SUBJECT: Historic Area Work Permit: Building addition and renovations

The Montgomery County Historic Preservation Commission (HPC) has reviewed the attached application for a Historic Area Work Permit (HAWP). This application was **Approved with conditions** at the June 24, 2020 HPC meeting.

Name of Easement Property:		Quince Orchard Colored School	
Alternative Name:			
Address of Property:		11810 Darnestown Road	
		Gaithersburg, Maryland 20878	County: Montgomery
Maryland Inventory of Historic Places # (if known): M 24-13 (for more information visit <a href="http://mht.maryland.gov/research_survey.shtml">http://mht.maryland.gov/research_survey.shtml</a> )			
Scope of Easement:	<input checked="" type="checkbox"/> Exterior <input type="checkbox"/> Interior <input type="checkbox"/> Archaeology	Is the scope of work located inside the easement boundary?	Yes <input checked="" type="checkbox"/> No <input type="checkbox"/>
What does the Easement protect? (Check all that apply)

Re: Pleasant View M.E. Church and Quince Orchard Colored School, Montgomery County  
Pending Easement  
Maryland Historical Trust Preservation Easement  
Loan of 2017, Chapter 22

PROPOSED SOUTH ELEVATION  
1/4 = 1' - 0"

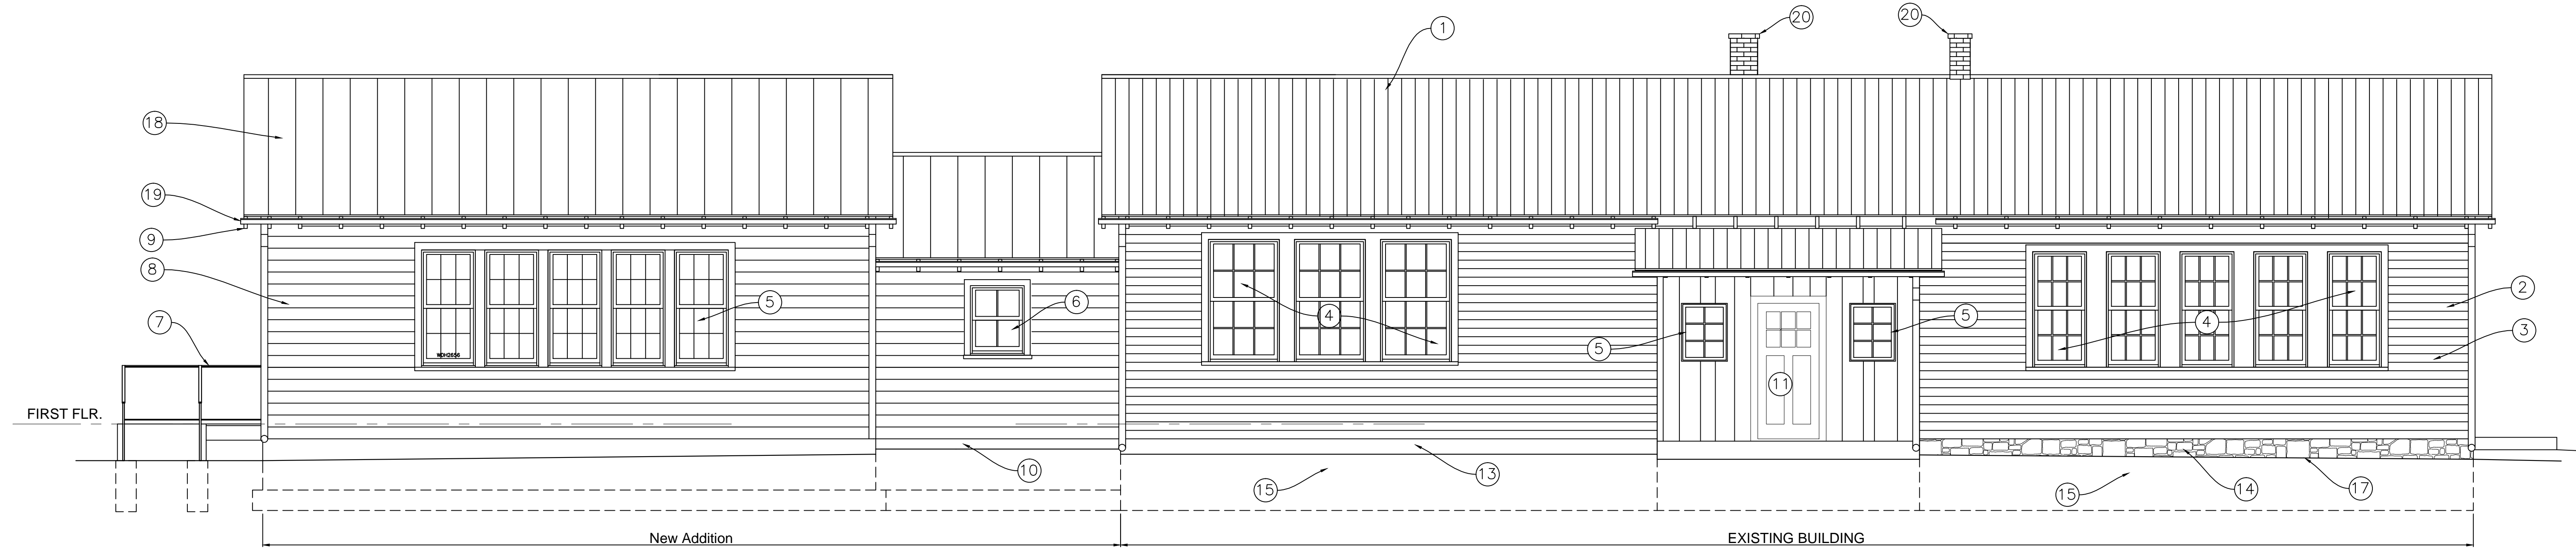
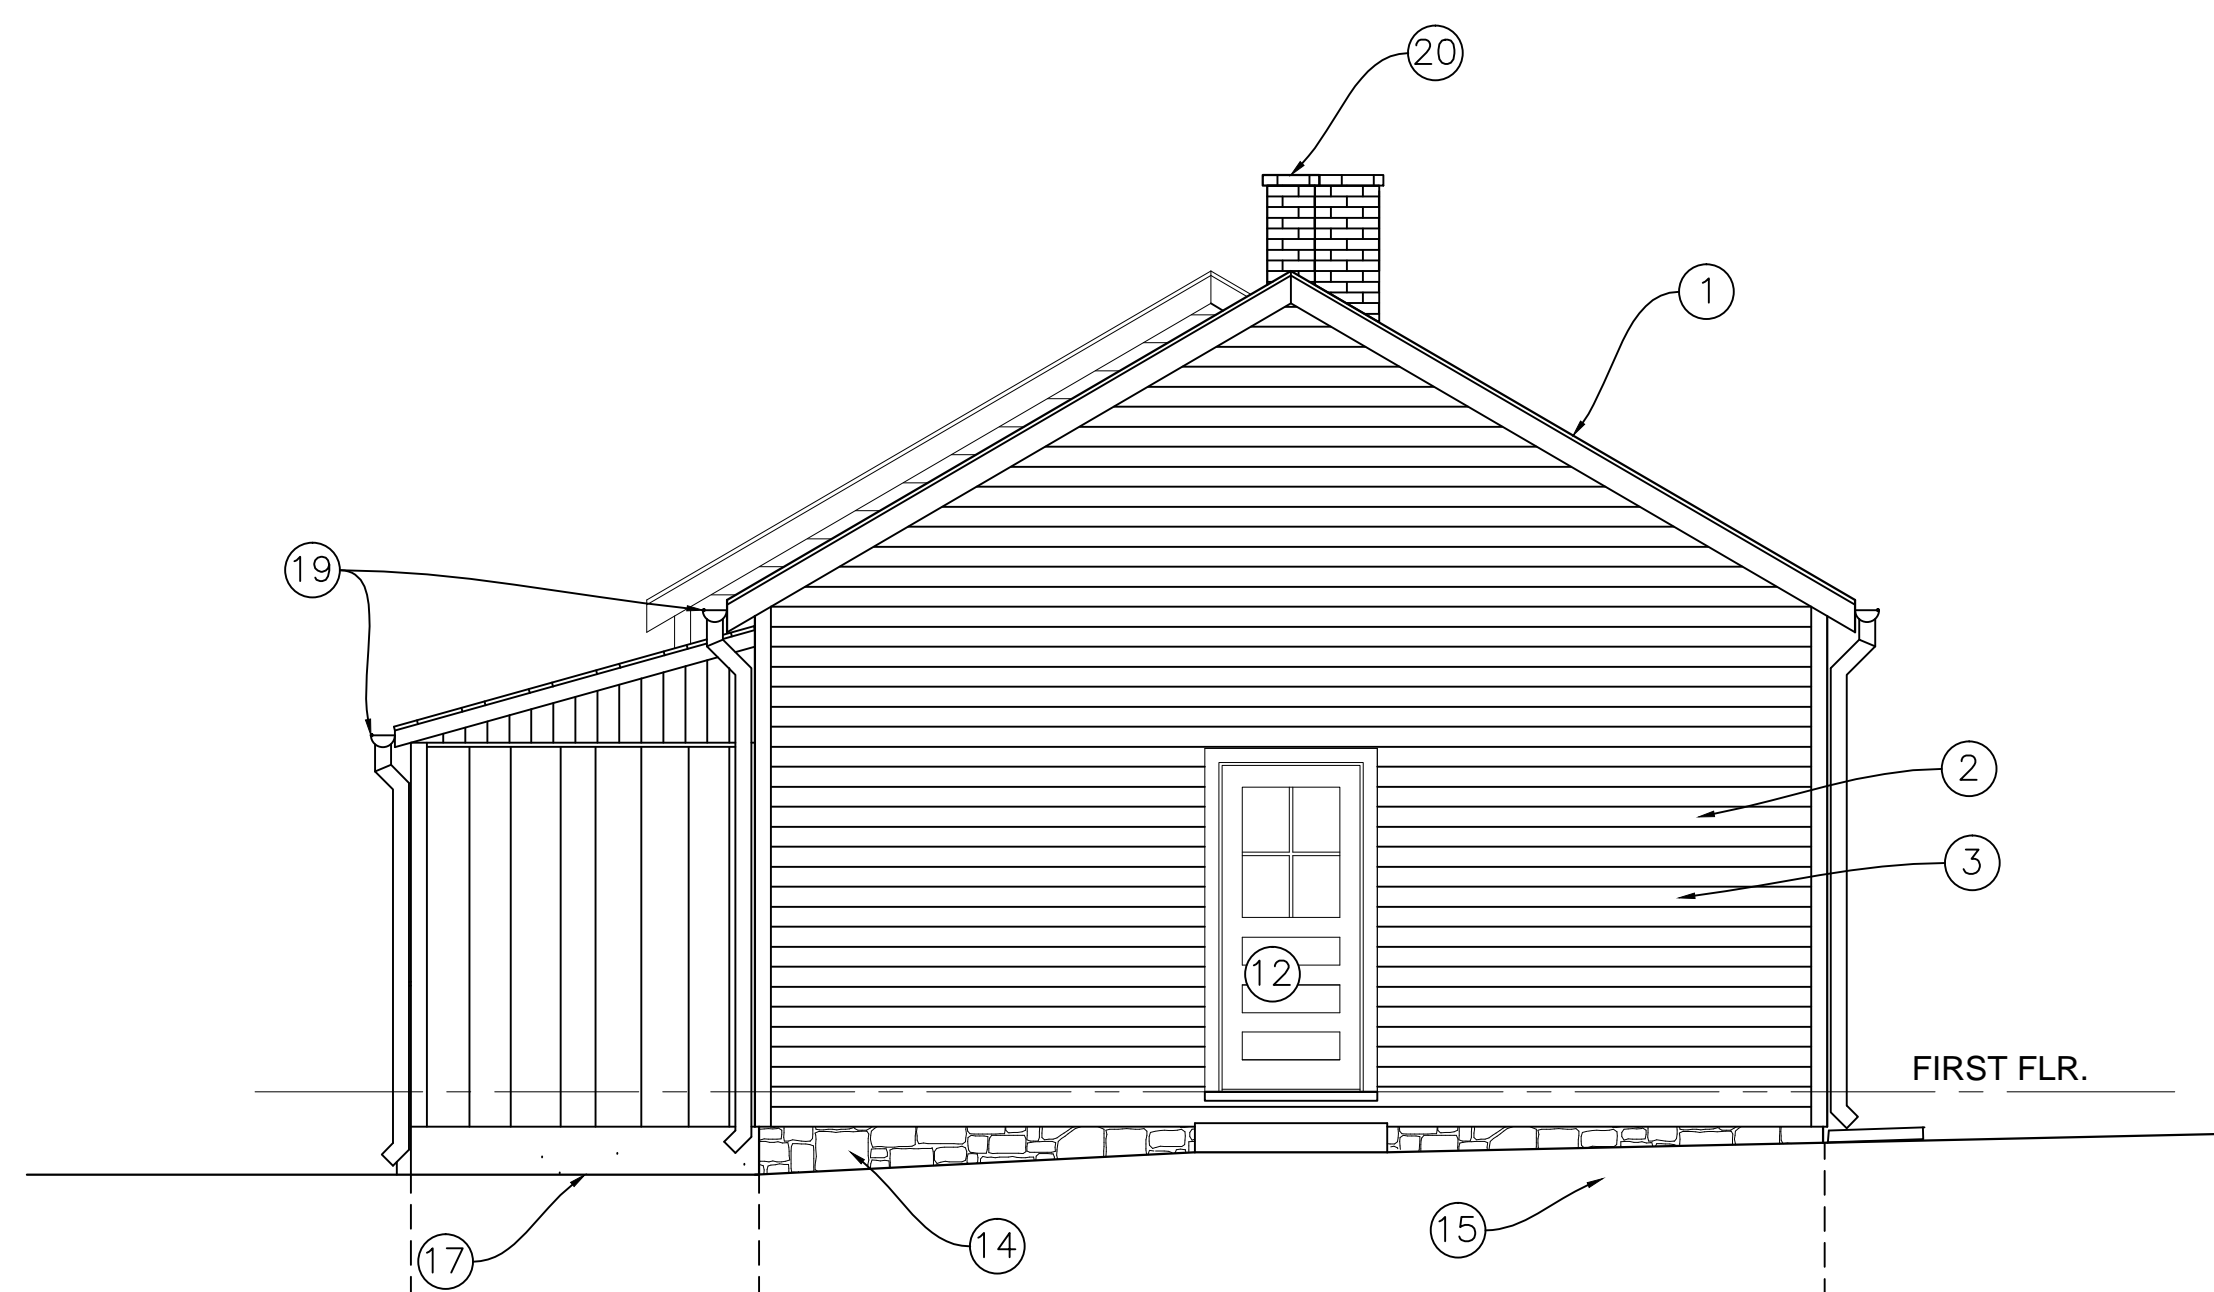
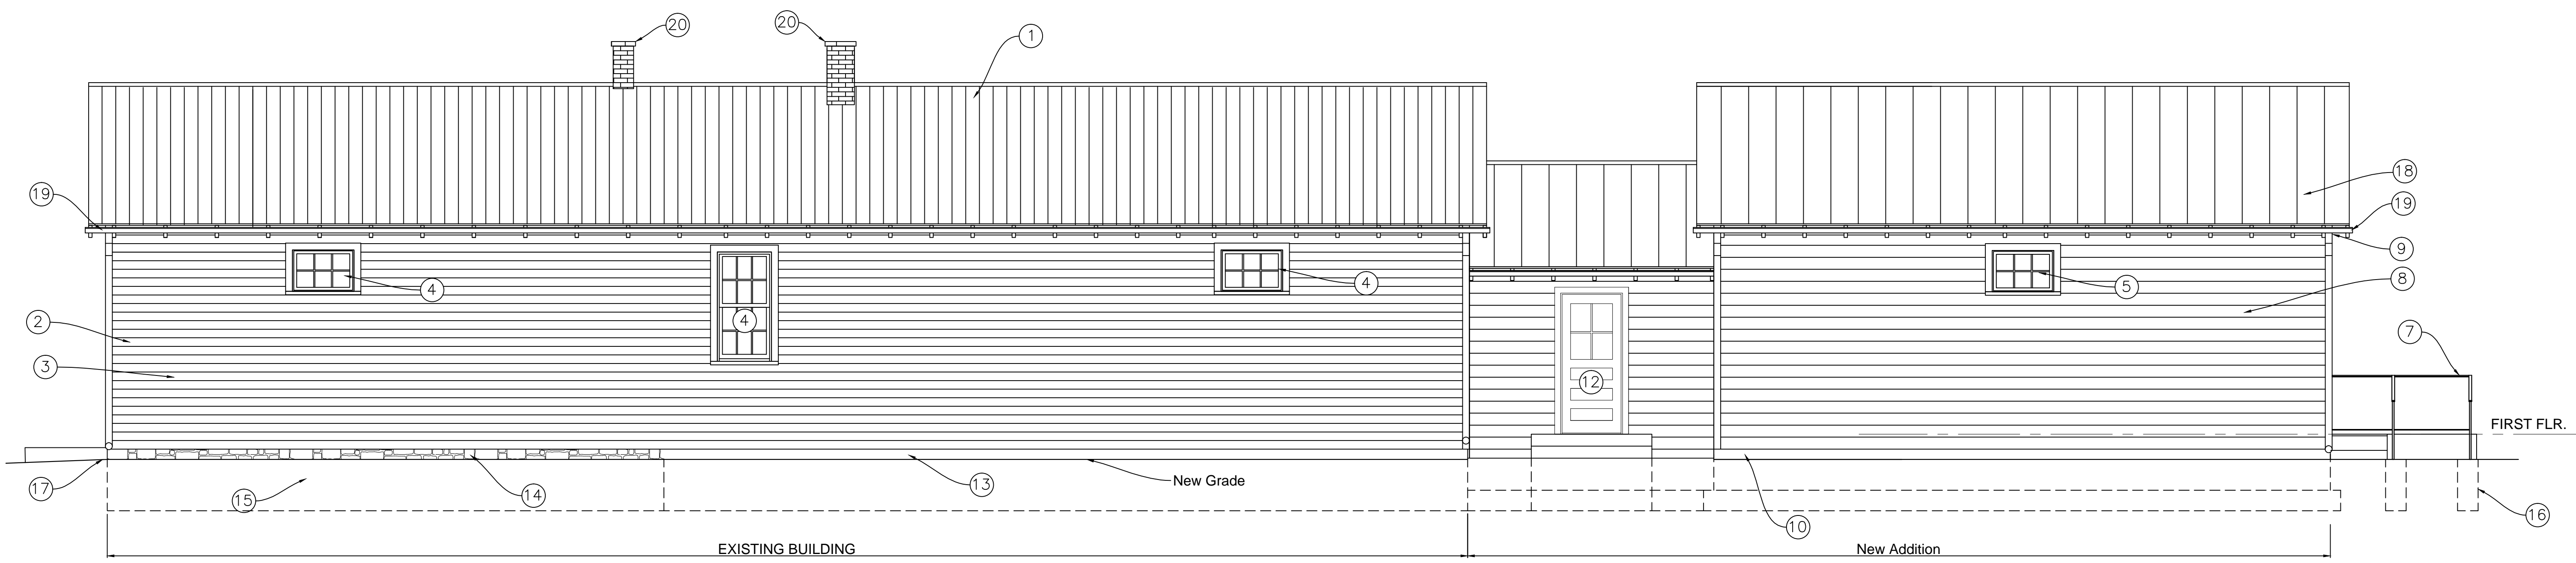
- 1. A mock-up of the new field stone foundation will be undertaken to ensure that the reconstructed wall matches in-kind. Once the mock-up has been completed, photographs should be submitted for review and approval.**

- A mock-up of the new field stone foundation wall be undertaken to ensure that the reconstructed wall matches in-kind. Once the mock-up has been completed, photographs should be submitted for review and approval.

CONTRACTOR NOTE:  
1. A MOCK UP OF THE REBUILT FIELD STONE FOUNDATION WALL TO BE REVIEWED AND APPROVED BY OWNER AND THE MARYLAND HISTORICAL TRUST.

CONTRACTOR NOTE:  
1. A MOCK UP OF THE REBUILT FIELD STONE FOUNDATION WALL TO BE REVIEWED AND APPROVED BY OWNER AND THE MARYLAND HISTORICAL TRUST.

CONTRACTOR NOTE:  
1. A MOCK UP OF THE REBUILT FIELD STONE FOUNDATION WALL TO BE REVIEWED AND APPROVED BY OWNER AND THE MARYLAND HISTORICAL TRUST.
